**Re: Case No. 19-1069-EL-BTA
In the Matter of the Application of AEP Ohio Transmission
Company, Inc. for an Amendment to the Certificate of
Environmental Compatibility and Public Need for the
Macksburg-Devola 138 kV Transmission Line Project**

Application for Amendment

Macksburg-Devola 138 kV Transmission Line Project

OPSB Case No. 19-1069-EL-BTA

Exhibit 1: Summary of the Alignment Changes to the Preferred Route**Engineering Adjustments**

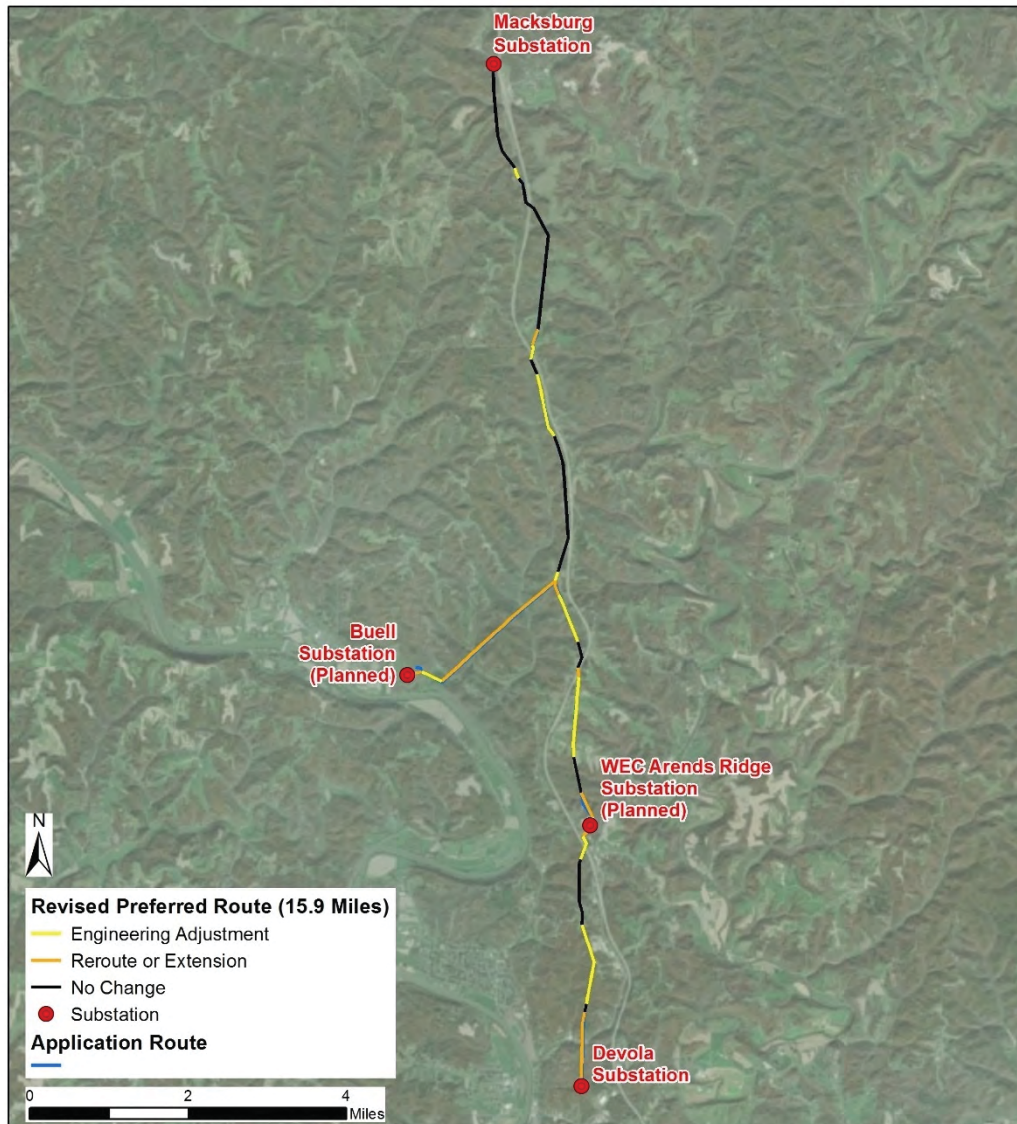
To assist in understanding the locations of the alignment changes, the Preferred Route has been split into three sections based on the description of the Preferred Route provided in the March 2017 application; Macksburg to Arends Ridge (formerly referred to as Highland Ridge in the March 2017 application), Arends Ridge to Devola, and Buell Extension. Prefixes to the structure numbers discussed herein indicate the section of the Preferred Route in which the structure is located. Structure numbers without letters are for the Macksburg to Arends Ridge section. Structure numbers with "AD" or "B" designate the Arends Ridge to Devola section and Buell Extension, respectively.

Exhibit 7. Map Illustration of Engineering Adjustment (Structures 16-AD through 24-AD)

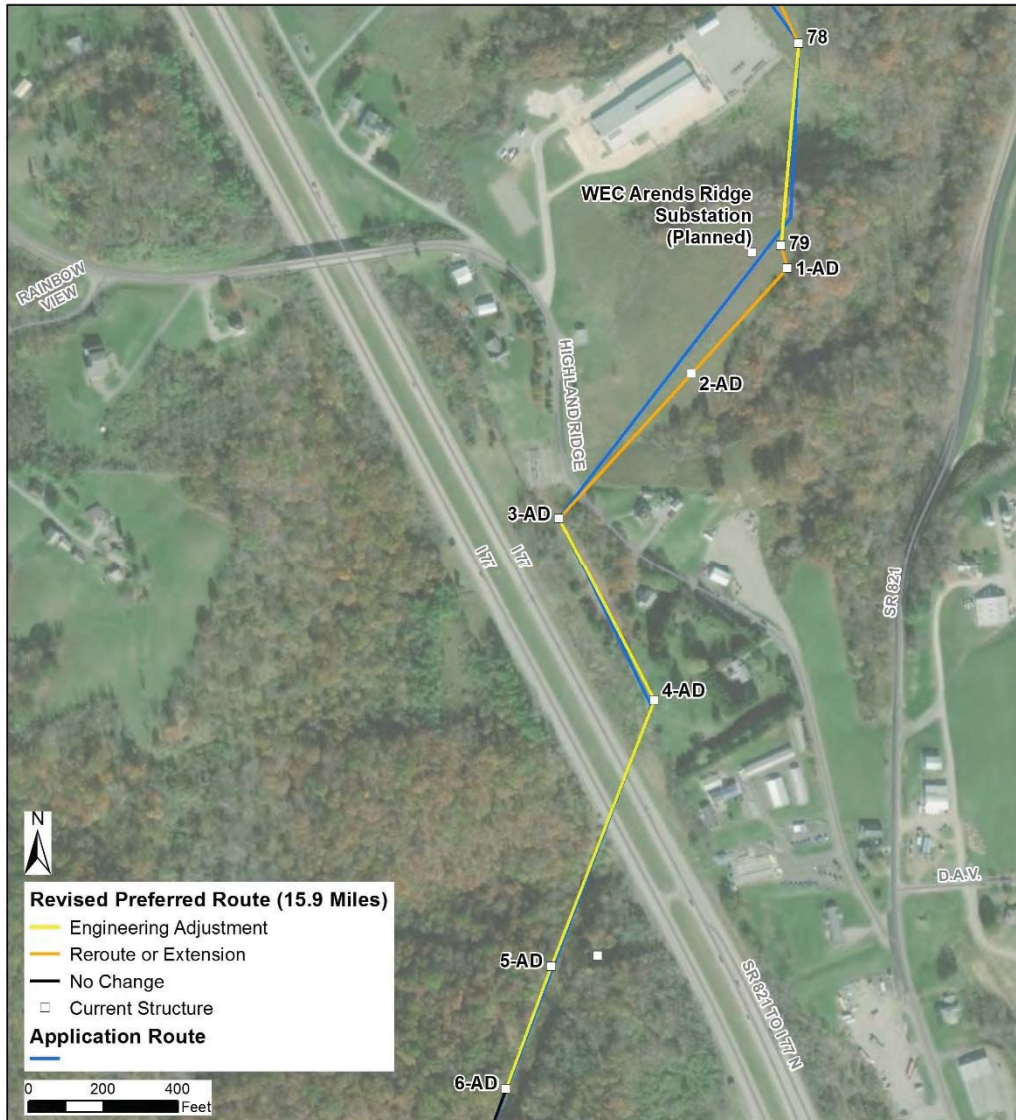
Engineering Adjustments 1 through 7 are located at various locations along all three sections of the Preferred Route. During the detailed engineering design phase of the Project (following submittal of the certificate application), the design team determined that the Preferred Route alignment was too close to the existing parallel overhead distribution line and as a result, extended outages of the distribution line would be required during construction. Shifting the alignment 10-30 feet to the west or east would provide enough clearance to the existing distribution line that extended distribution outages would not be needed. These engineering adjustments along the Preferred Route are shown below in the series of Exhibits 2 through 8.

Exhibit 13. Map Illustration of Reroute 2 (Structures 25 through 27)

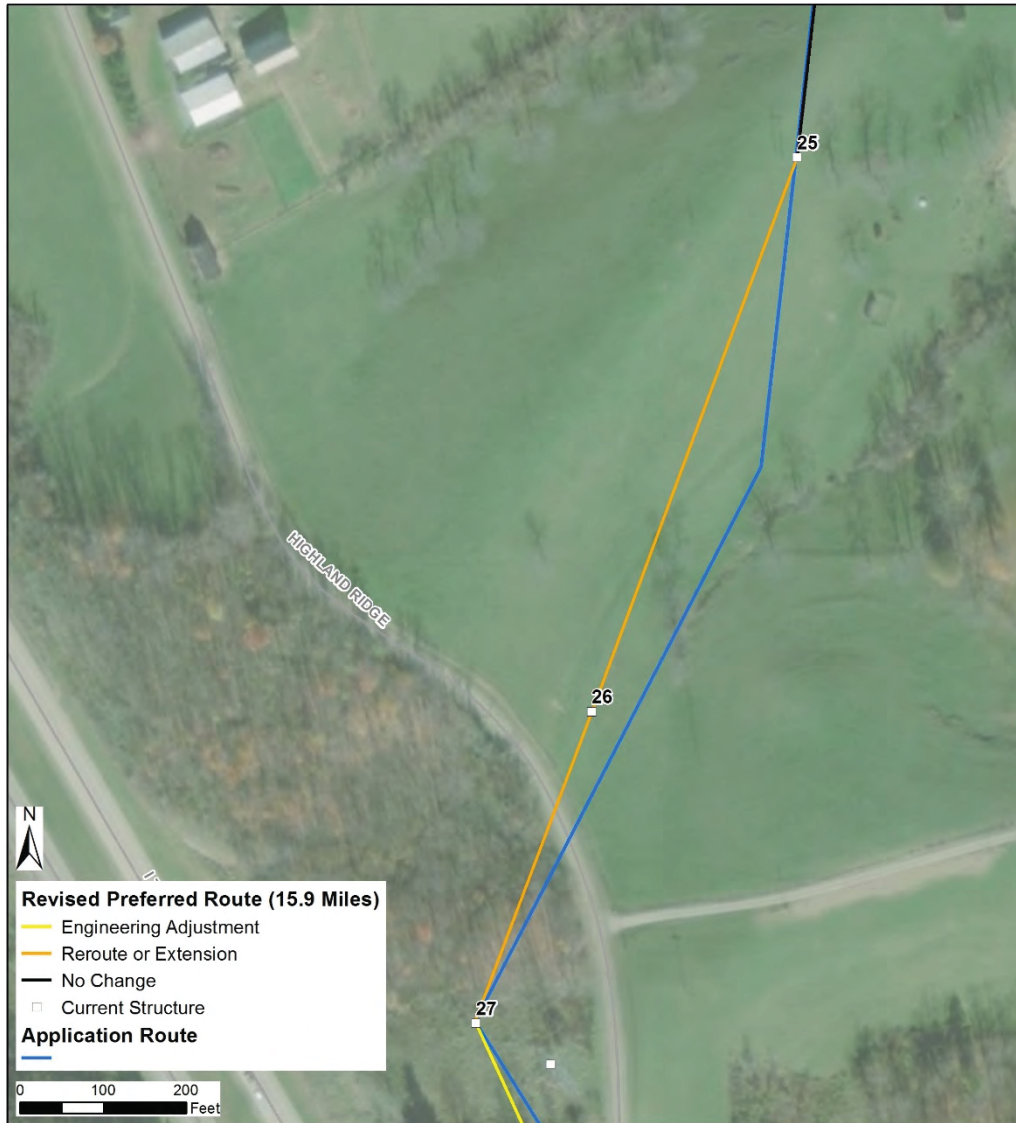
Reroute 2 is located in the northern portion of the Macksburg to Arends Ridge section. This reroute, as shown in Exhibit 13 below, is due to eliminating an extra transmission line structure on the landowner's property thereby requiring Structure 26 to shift west approximately 50 feet. The application route paralleled an existing distribution line for a portion of this segment. This reroute would result in less than 0.1 acre of additional tree clearing.

Exhibit 16. Map Illustration of Reroute 5 (Structures 75 through 78)

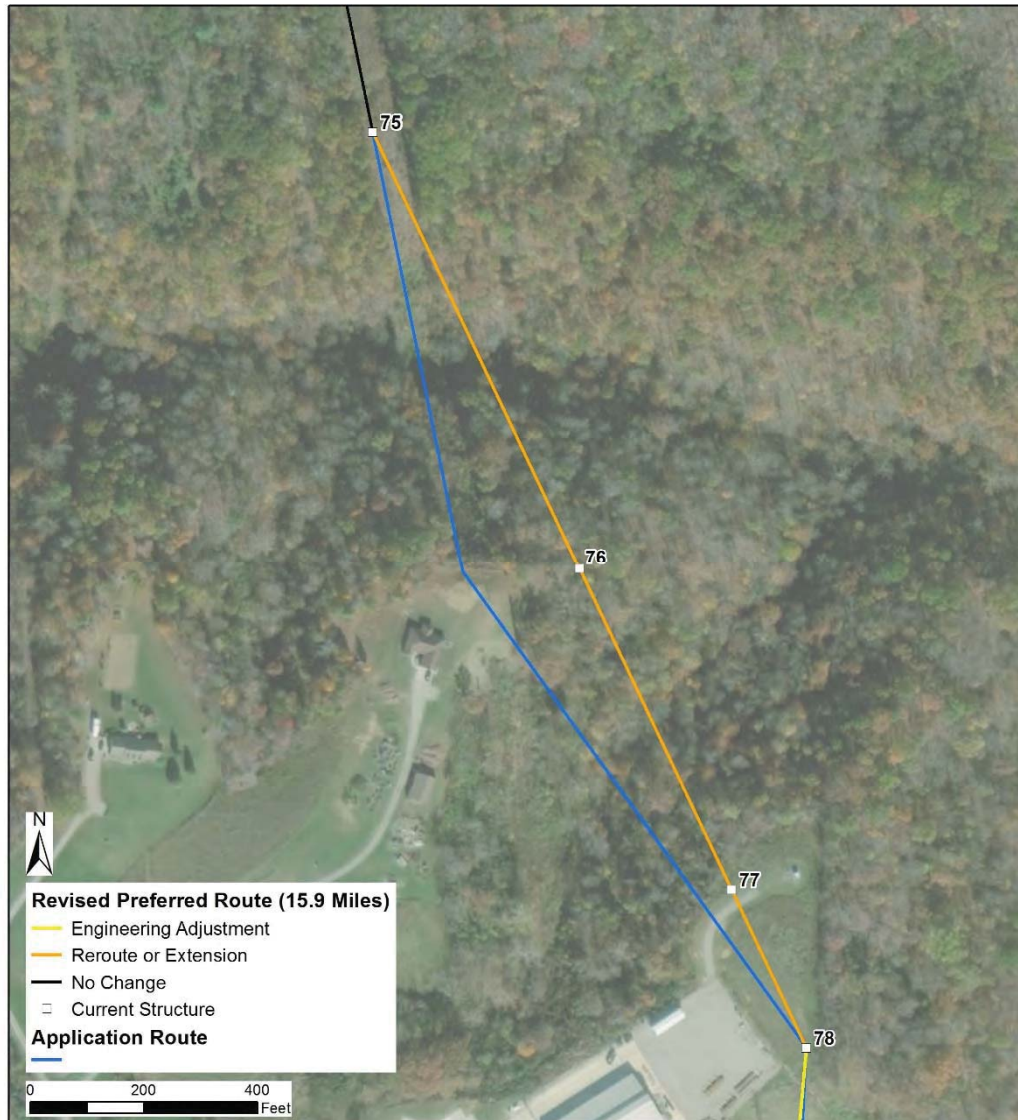
Reroute 5 is located at the southern end of the Macksburg to Arends Ridge section. This reroute, as shown in Exhibit 16 below, is due to the property owner's request which resulted in shifting the location of Structure 76 and the alignment approximately 200 feet east. This reroute would result in an additional 1.0 acre of tree clearing.

Exhibit 18. Map Illustration of Reroute 7 (Structures 25-AD through Arends Ridge - Devola Substation)

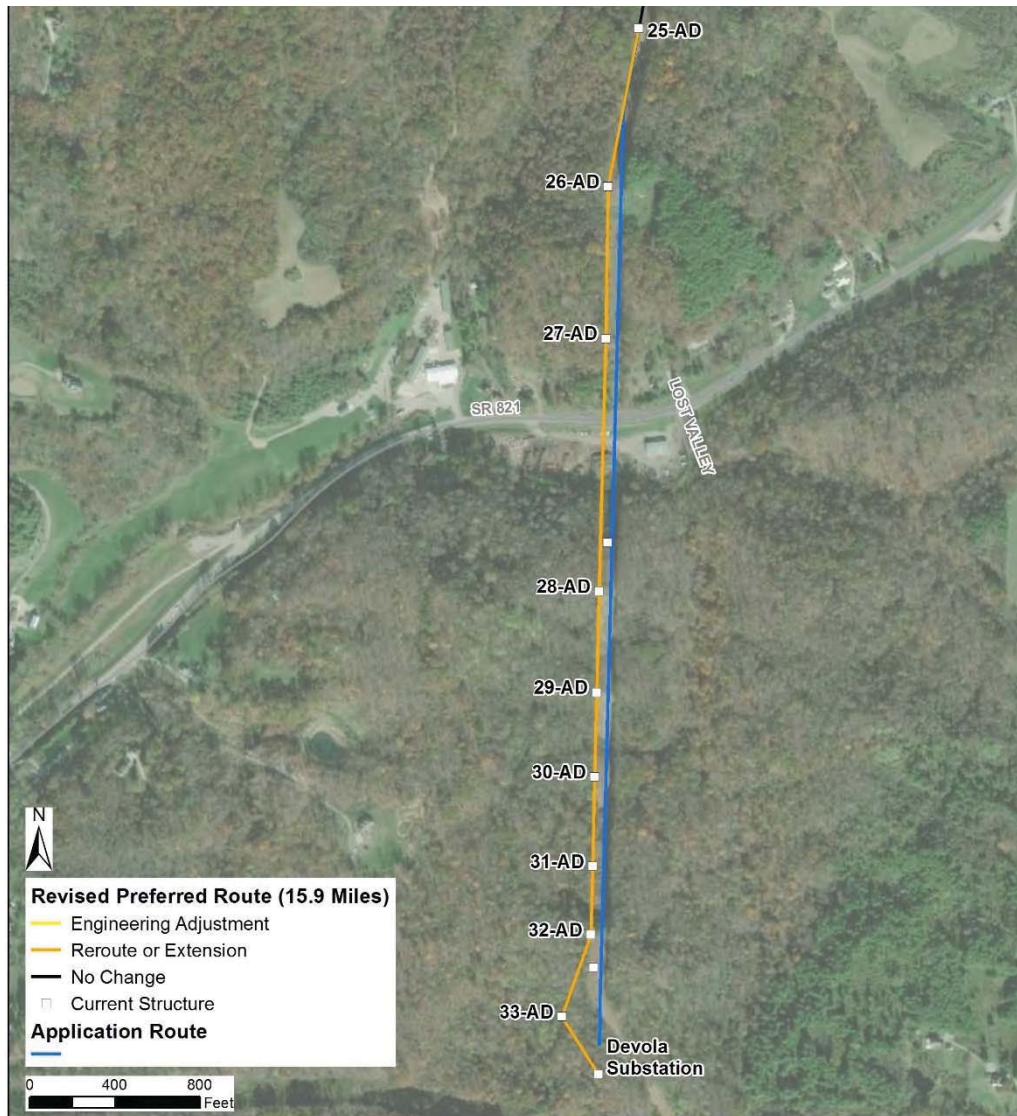
Reroute 7 is located along the Arends Ridge to Devola section. This reroute, as shown in Exhibit 18 below, is due to the Preferred Route alignment located too close to the existing overhead distribution which would require extended outages of the distribution line during construction. Shifting the alignment approximately 52 feet to the west would provide enough clearance to the existing distribution line that extended distribution outages would not be needed. This reroute would result in approximately 1.5 acres of tree clearing.

Exhibit 20. Map Illustration of Reroute 8 (Structures 6-B through 18-B)

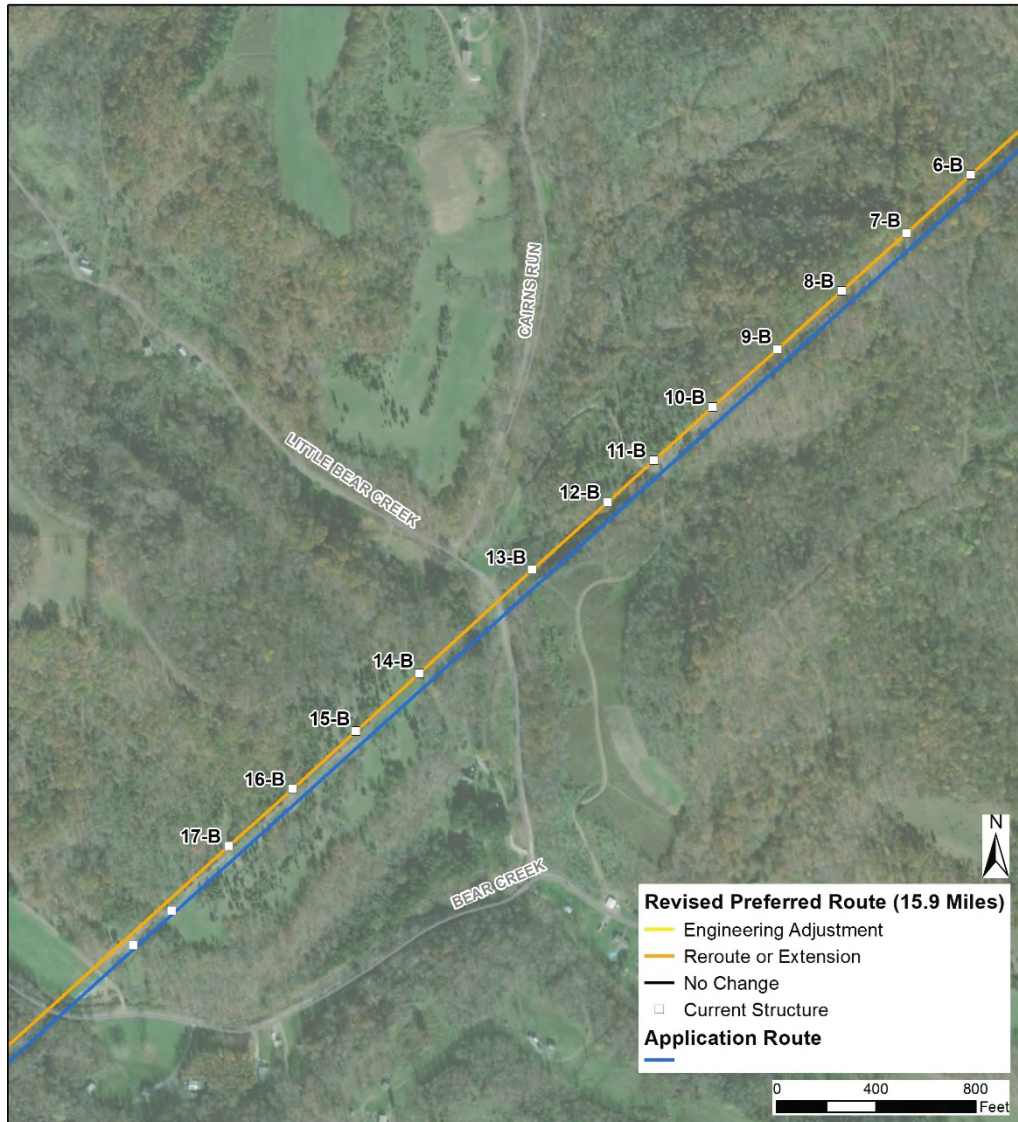
Reroute 8 is located along the Buell Extension. This reroute, as shown in Exhibits 19 and 20 below, is due to the need for adequate clearance between the Preferred Route alignment and the existing overhead distribution line, which would otherwise require extended outages of the distribution line during construction. The OPSB's staff also recommended a shift due to the number of riparian trees that would need to be cleared near Structure 4-B. Shifting the alignment approximately 60 feet to the west provides sufficient clearance from the existing distribution line, eliminates the need for a crossing of the existing distribution line, and reduces the impact to riparian trees. This reroute would result in an additional 1.9 acres of tree clearing.
